**TOWN OF HERNDON, VIRGINIA
ARCHITECTURAL REVIEW BOARD
VIRTUAL WORK SESSION AGENDA
OCTOBER 7, 2020
HERNDON COUNCIL CHAMBERS BUILDING
765 LYNN STREET
7:30 P.M.**

Subject: October 2020 ARB Work Session Case Update, ARB #20-019, 1051 Elden Street

Case Number & Type: ARB #20-022, New construction
Case Summary: Construct a new telecommunications tower (monopole), with tower-mounted and ground-mounted telecommunications equipment and ground level security fence
Case Location: 525 Grove Street, Dominion Power substation site

In this memo, staff offers its second set of design review comments for the Board to assess response to previous staff and Board comments, the qualities of the proposed design (at this stage of the process) and address any additional design information or aspects of the project that the Board could not evaluate due to missing information. The applicant has re-submitted a design exhibit (Attachment #2) with the following new information:

Proposed Sign with Measurements

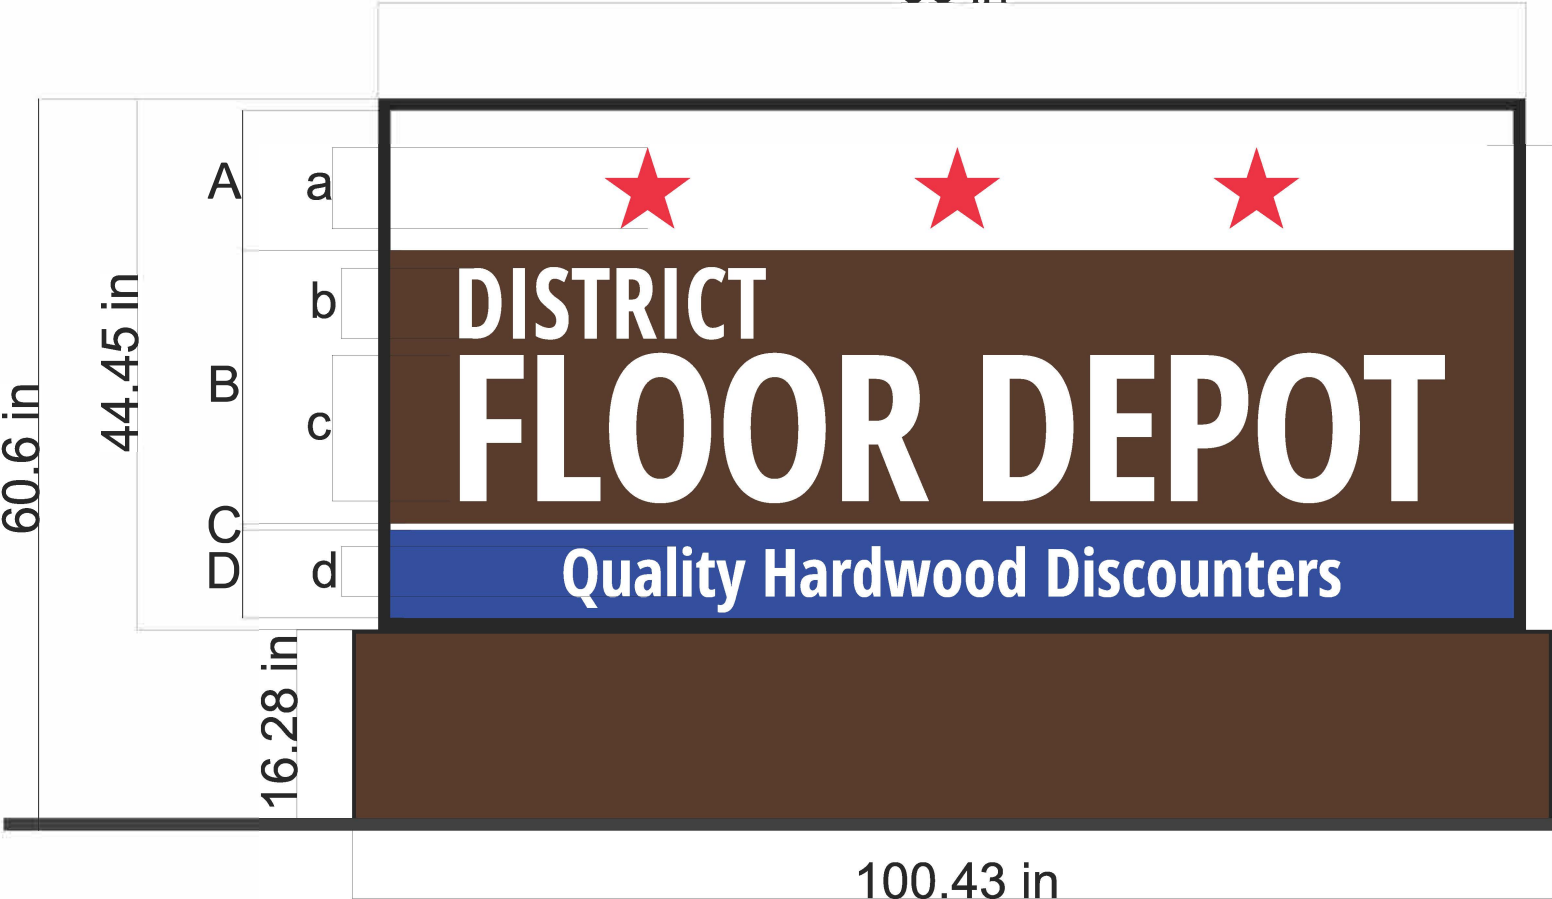
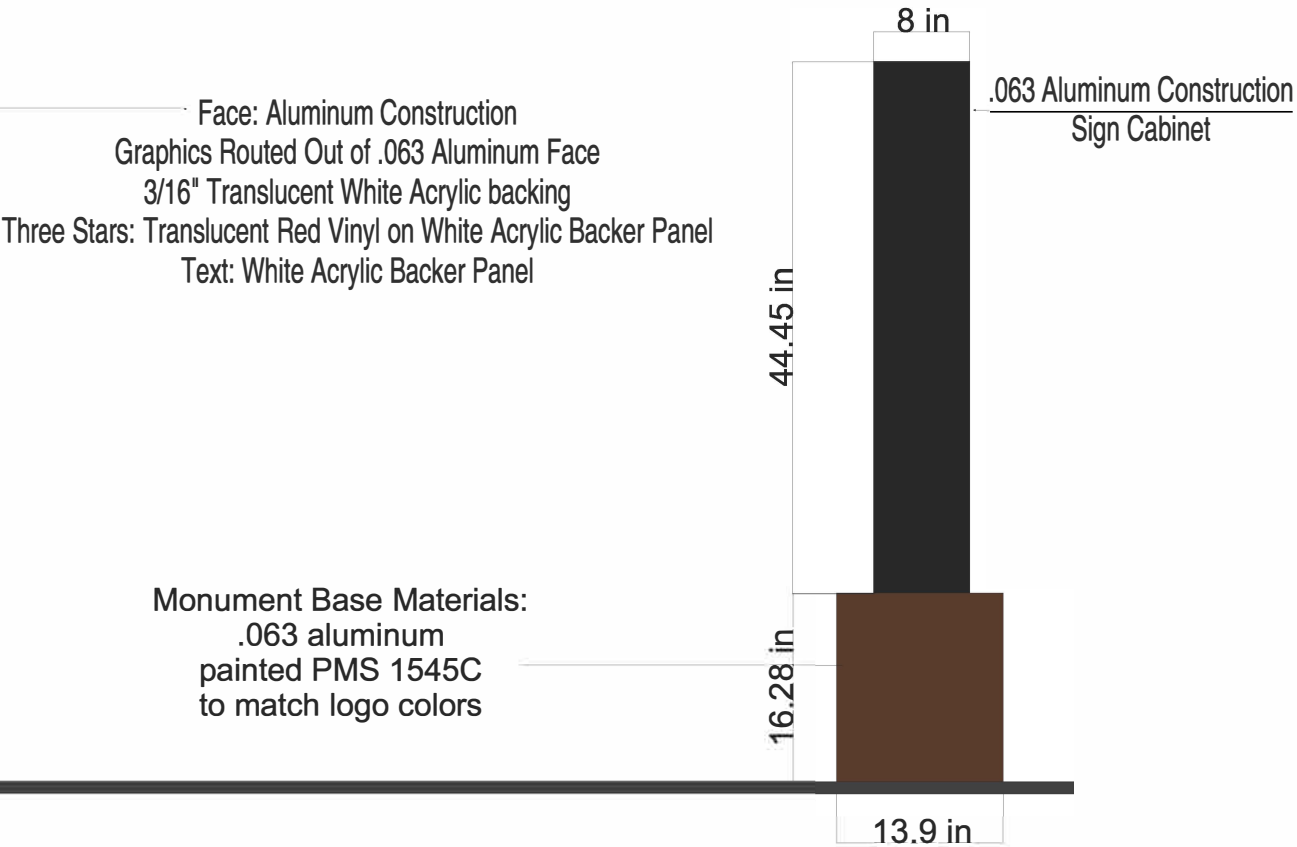
In the latest rendition, the applicant has revised the sign base to be approximately 8'-6" long by 1'-2" wide and 1'-4" tall and constructed of a 0.63" thick aluminum base painted brown (PMS 1545C) to match the existing logo colors. In addition, the applicant has provided perspective renderings depicting 4' landscaping areas around the sign required by the Town's Zoning Ordinance Section 78-140.6 and Section 78-141.4.

Staff is generally supportive of the revised design. However, staff feels the sign base color should be either a matte black to match the sign edge panels or a dark bronze to match the existing building's storefront metal framing. Staff finds that this minor color adjustment will clearly accentuate the corporate identity and color arrangements of the primary sign faces and be more compatible with the primary commercial building's architecture.

- 1) Prior to issuance of a building permit, the applicant shall revise the sign base color to be either a matte black to match the sign edge panels above the sign base or a dark bronze to match the existing building's storefront metal framing and submit the revision to Town staff for inclusion in the ARB case file;**

1 BOLLARD DETAIL
D-1 NTS

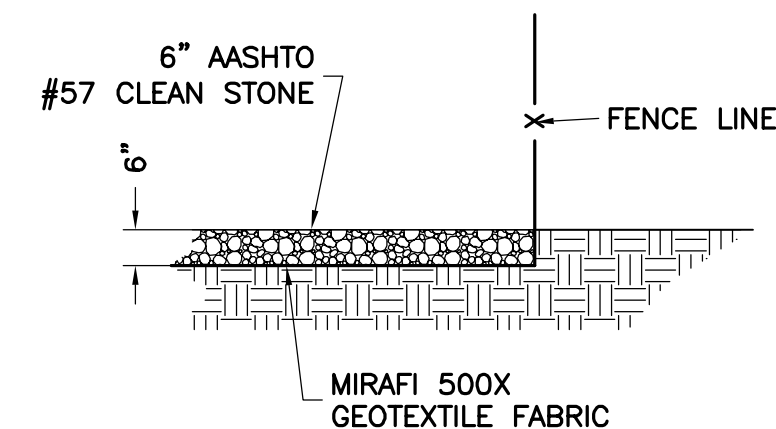
No color information was provided for the access bollards and should be provided a condition of approval in accordance with provisions found in Special Exception #19-02, as approved.

4 TYPICAL FENCE DETAIL
D-1 NTS

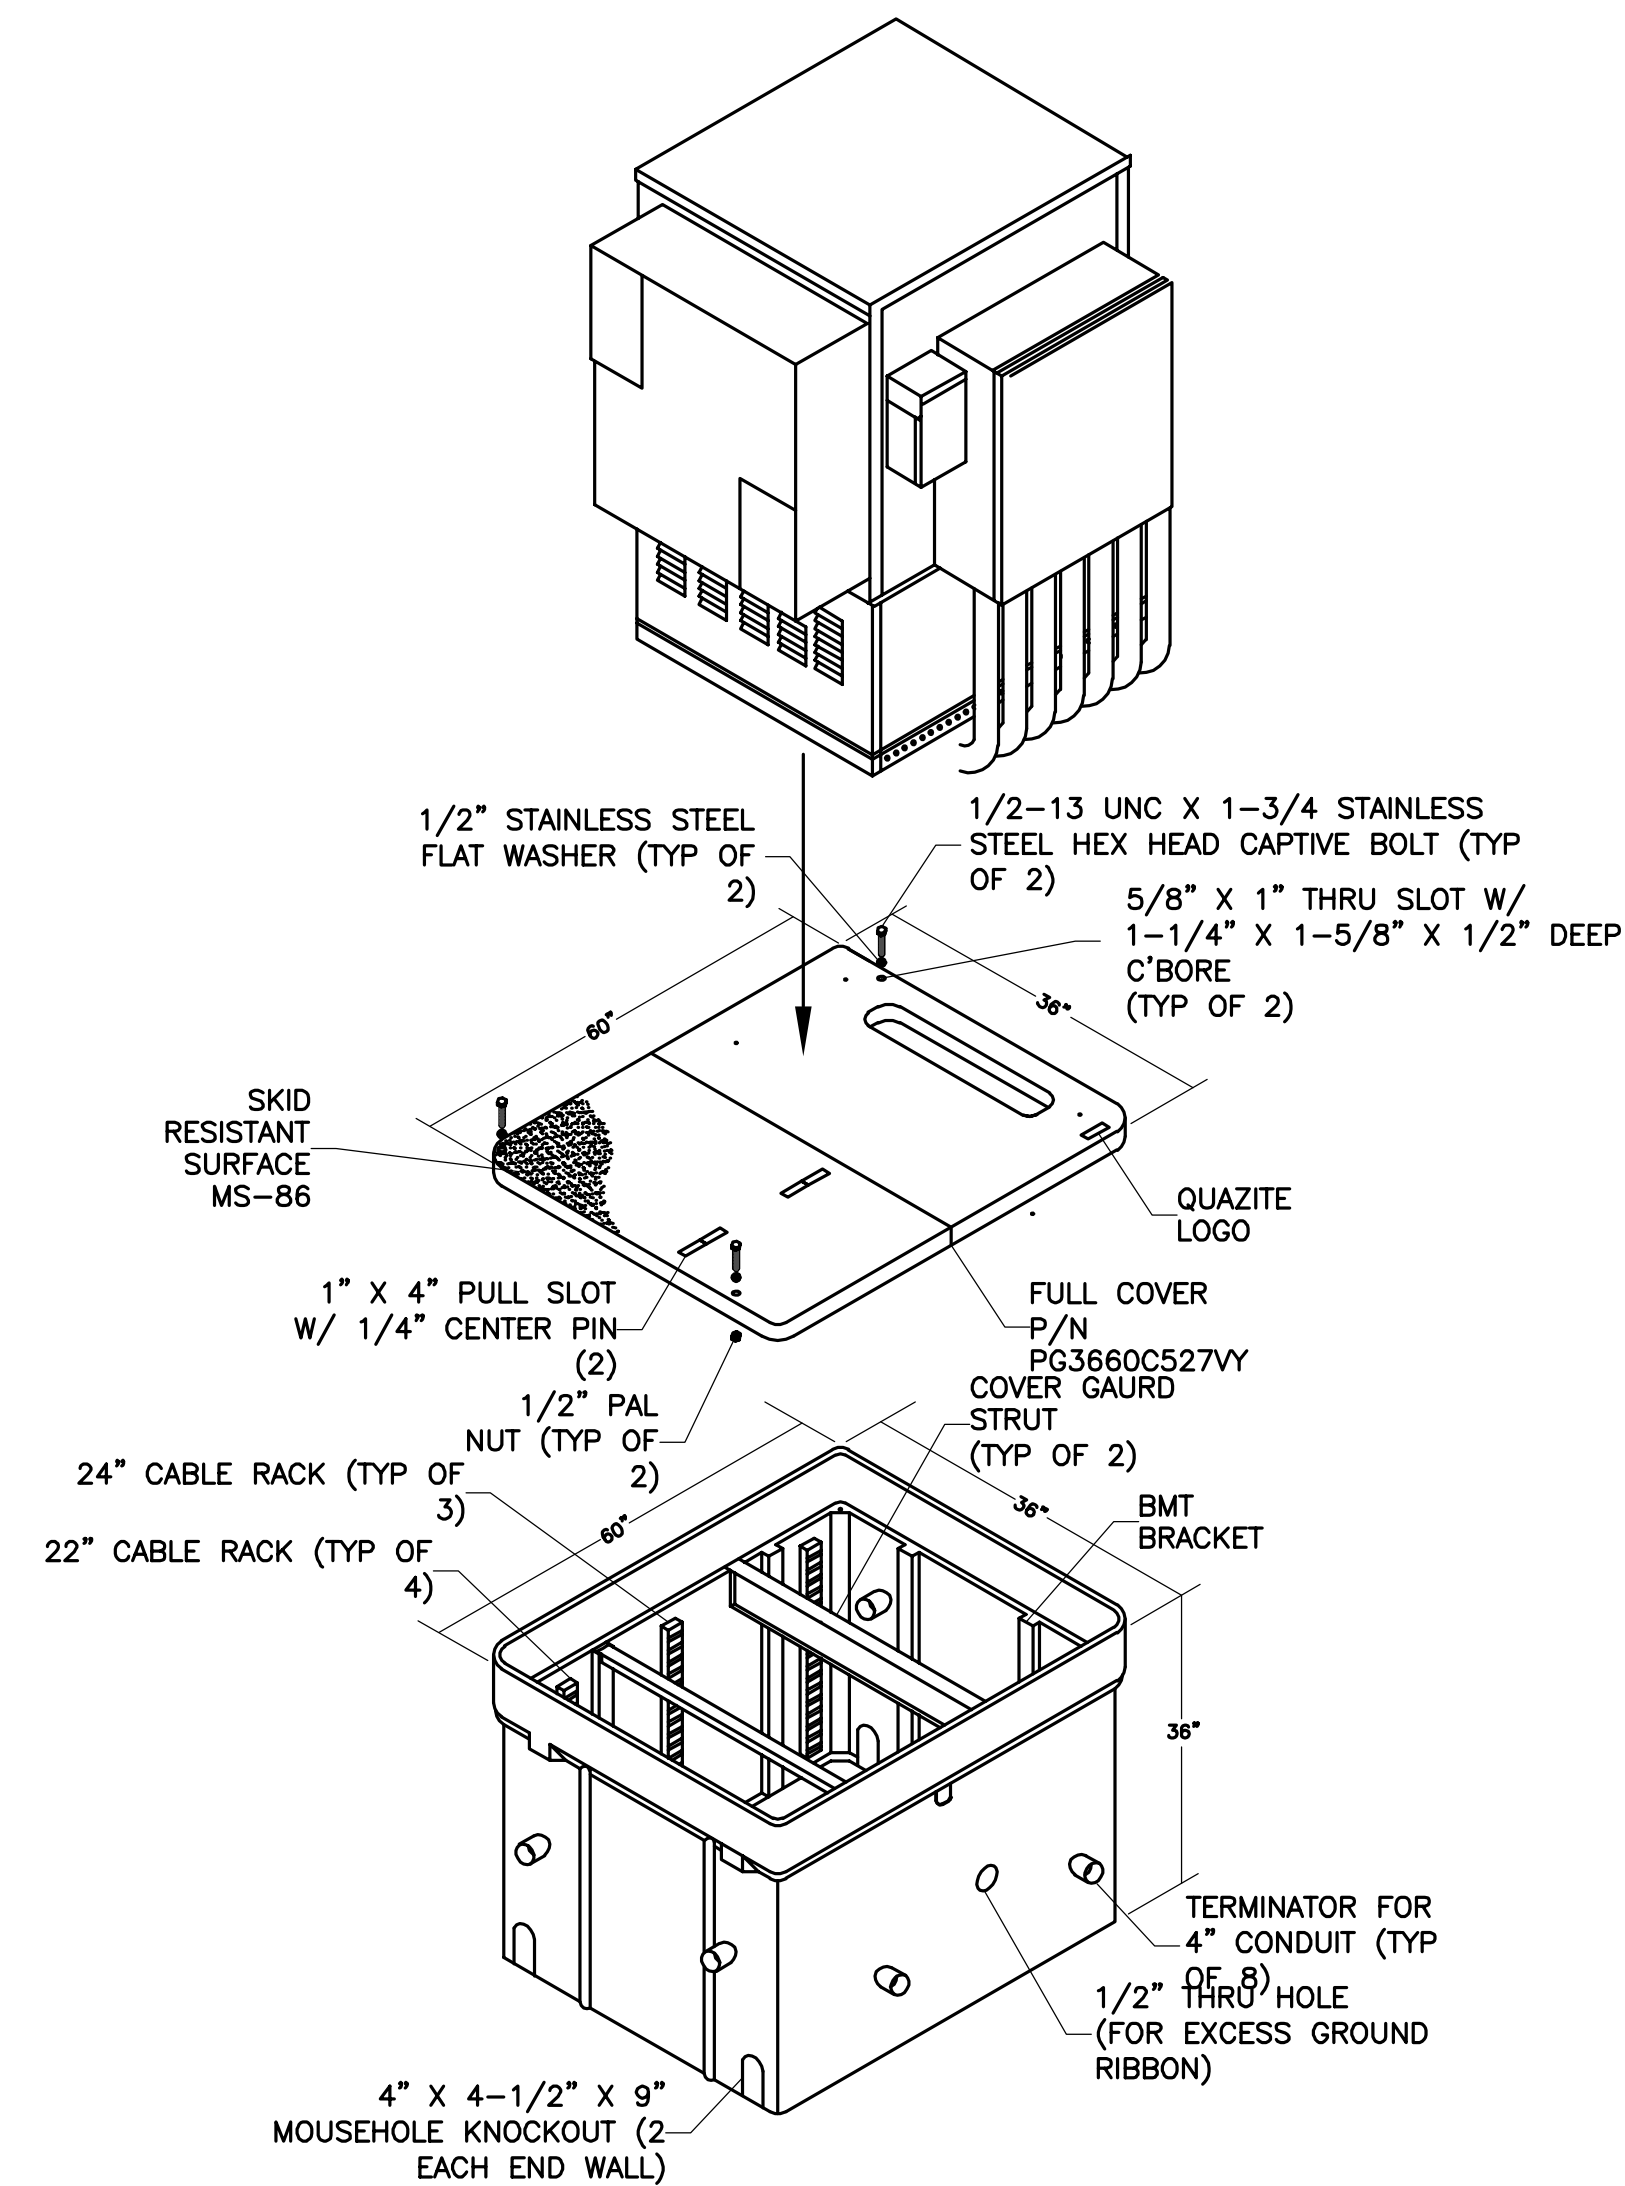
1. Staff field investigation of the site was conducted closer to the site to further understand the visual impact of the new compound and telecommunications monopole, most notably along Grove Street. While staff has determined that the new fenced enclosure will likely not be visible from Grove Street, it will be minimally visible from the W&OD Trail after removal of existing vegetation and landscaping and installation of new landscaping as approved through the approved site plan, TP #19-01. Though minimally visible from the W&OD Trail, staff finds that the proposed fence design is generally appropriate. However, staff recommends that if fence picket

options with more narrow spacing are available, then an option of this nature should be installed to more effectively screen proposed and future equipment installations within the fenced enclosure at ground level while achieving the facility owner's security needs, and achieving conformance to the Town approved special exception and proffer condition amendments.
